Proposal for Supplement 18 to the 00 series of amendments to Regulation No. 4

(REAR REGISTRATION PLATE LAMPS)

Note: The text reproduced below was prepared by the expert from Japan to add registration plates used in non-European Contracting Parties based on GRE-69-23. The modifications to the existing text of the UN Regulation are marked in bold for new or strikethrough for deleted characters.

Space for a plate of Category 2a (330 x 165 mm)

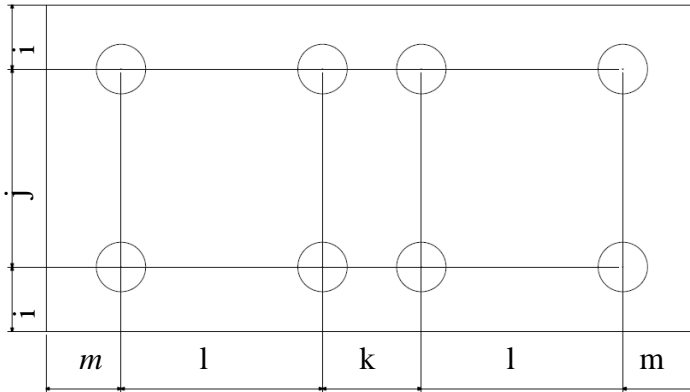
Annex 3, amend to read:

Annex 3
MEASUREMENT POINTS FOR TEST PURPOSES

i= 32.5mm

Space for a plate of Category 2b (440 x 220 mm)

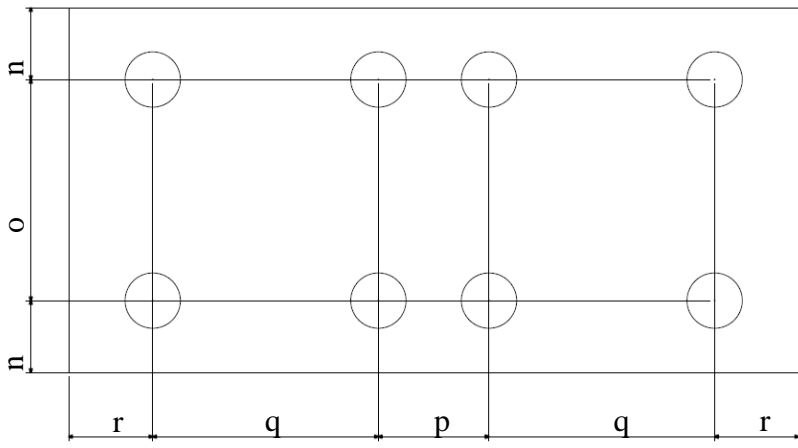
n=50mm

o=120mm

p=50mm

q=145mm

r=50mm
